Summary of Items Discussed in 1/2016 APSEC Discussion Forum on 15 January 2016

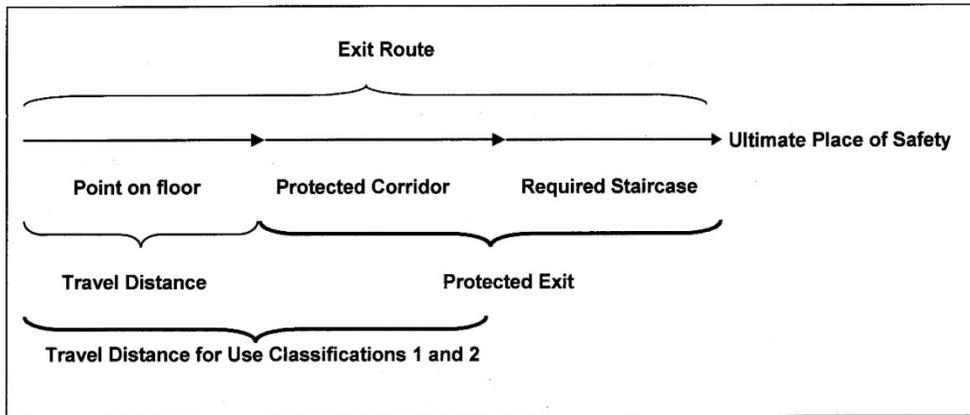
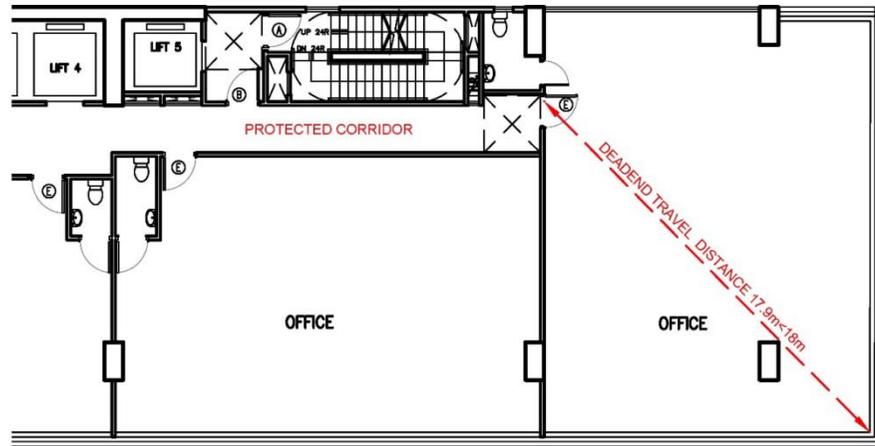
Item raised by AAP	
5.	<p><u>Code of Practice for Fire Safety in Buildings (FS Code) – Clause B11.2</u></p> <p>In respect of the following statement of Clause B11.2(c)(i) as stipulated in the Code of Practice for Fire Safety in Buildings 2011,</p> <p>“The deadend travel distance is limited to :-</p> <p>.....</p> <p>.....</p> <p>(c) for all other use classifications:-</p> <p>(i) 18m to the protected exit or to a point, from which travel in different directions to 2 or more exits is available;”</p> <p>(d)</p> <p>and according to Section 3 - Definitions, Diagram A2: Illustration of Exit Route as stipulated in the same Code,</p>	BD confirmed that the dead end distance shown on the diagrammatic floor plan for office accommodation was a correct interpretation of Clause B11.2(c)(i) of the FS Code, provided that the corridor outside the office unit was fully protected.

“Protected Exit” include the “Protected Corridor” for Use Classifications other than Use Classifications 1 and 2.

In this regard, please confirm that the deadend travel distance for the office as shown on the floor plan below is acceptable if the corridor outside the office unit is fully protected.

6. **Void Covered by the Transfer Plate or Footprint of a Domestic Tower**

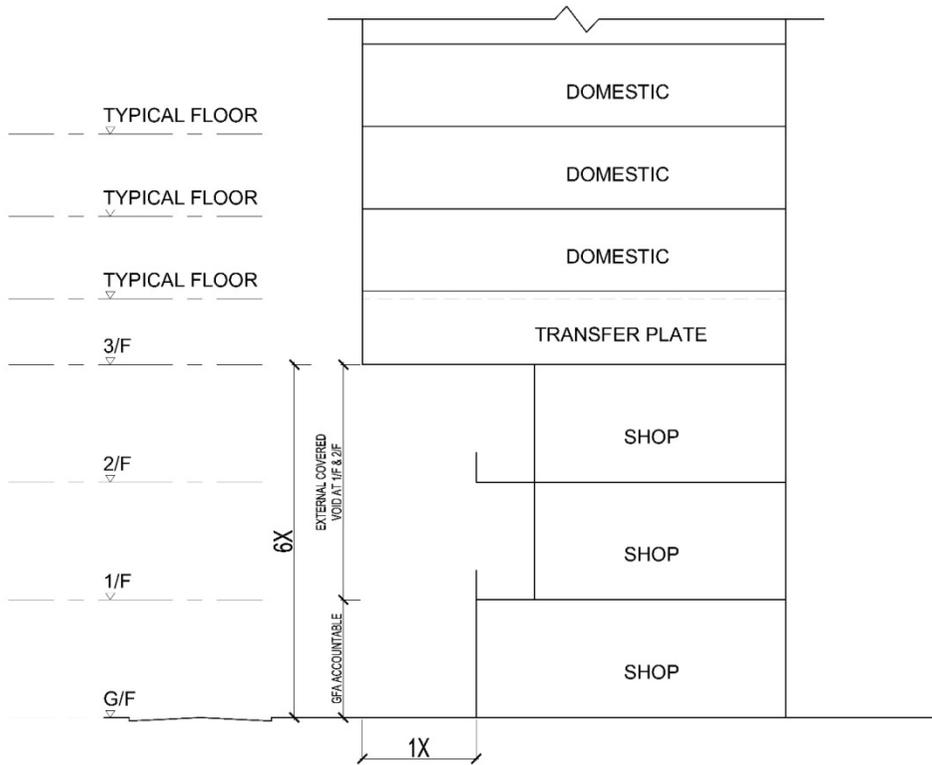
Please confirm if void areas in the podium floors covered by the transfer plate or footprint of a domestic tower can be exempted from GFA calculation by considering as voids in a shopping arcade subject to a 10% cap.

BD noted that if the building was a genuine shopping arcade and the void was not excessive (i.e. subject to 10% of the total GFA of the arcade under APP-2 but not to the 10% cap under PNAP 151), such space above ground could be exempted from GFA in principle. In other words, GFA exemption under PNAP APP-2 for voids over shopping arcade could apply to voids not just at the center but also applicable in principle to the periphery of buildings with or without an external wall. BD reminded that the G/F of such voids would not be exempted.

The discussion carried further that if the ratio of space at the periphery is bigger than 1(W):8(H), only the G/F would be included in accountable GFA. If less, configuration of the recession would be considered “open” enough and the G/F could be excluded from GFA.

In any case, the intermediate floors would not be included.

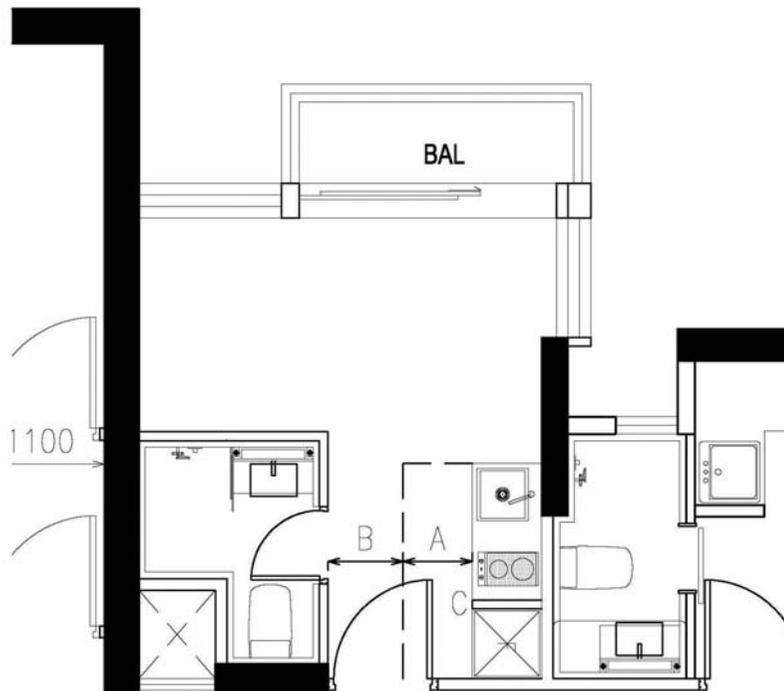
<p>corridor.</p> <p>We also understand that the idea of 'notional kitchen area' was brought up in discussions with BS.</p> <p>We hope the following guidelines to facilitate the design and submission can be provided:</p> <p><i>Notional Kitchen Area</i></p> <p>Notional kitchen area – what is the acceptable minimum dimension for such notional kitchen area? (A)</p> <p><i>Minimum remaining width from A to wall?</i> (B)</p> <p>When sufficient space is provided, will the 600mm wall be still required? (C)</p>	<ol style="list-style-type: none"> 2. The purpose of the “wall” mentioned in Clause C13.4(d) of the current FS Code was to shield the evacuees from radiant heat of stove fires, allowing the necessary pause of evacuees to open the door (and gate) without being seriously charred. This wall would be essential unless the stove was placed sufficiently far from the exit. From the advice of the Technical Committee on the various open kitchen layouts presented and an expert’s advice on the effect of radiant heat flux to the evacuees at the exit door, the minimum distance for a sprinkler controlled household stove fire without shielding by walls should be 2m measured from the nearest corner of the stove to the door knob when the exit door was in closed position. 3. The following two phenomena recently found in some open kitchen designs had posed threat to fire safety and undermined the relevant standards as stipulated in the Code: <ol style="list-style-type: none"> a) The “wall” though provided but at locations not performing the intended shielding function for the exit and the stove was less than 2m from the exit door (considered not meeting code-compliant equivalent standard), and b) The design of open kitchens in small studio flats which a very congested environment would be expected (considered in such case the stove could be very near to main circulation routes or storage of combustibles, irrespective of (i) whether the wall was performing the intended shielding effect for the exit and (ii) location of the stove was more or less than 2m from the exit or not, therefore a highly undesirable scenario not specifically addressed by the Code). 4. The demarcation of notional kitchen area as proposed in the meeting might help but would not significantly reduce the risks mentioned in para. 3. 5. Scenario 3(a) would be regarded as a contravention. New proposals would not be accepted. If such design was insisted,

A = NOTIONAL KITCHEN (SPACE IN FRONT OF COUNTER TOP)
 C: WILL THE 600MM WALL STILL BE REQUIRED?

additional compensatory measures on top of the current code requirements might be necessary for consideration on case basis, and by the Fire Safety Committee (FSC) if necessary.

- 6. Scenario 3(b) with the provision of effective shield wall or sufficient distance between door and stove could be regarded as code-compliant but undesirable. APs were advised to consider on a voluntary basis a choice of safer stove or other compensatory measures for such flats.
- 7. BD invited members to view from the internet how the intervention of water could aggravate a fire involving cooking oil to appreciate the fire risk involved under sprinkler control.
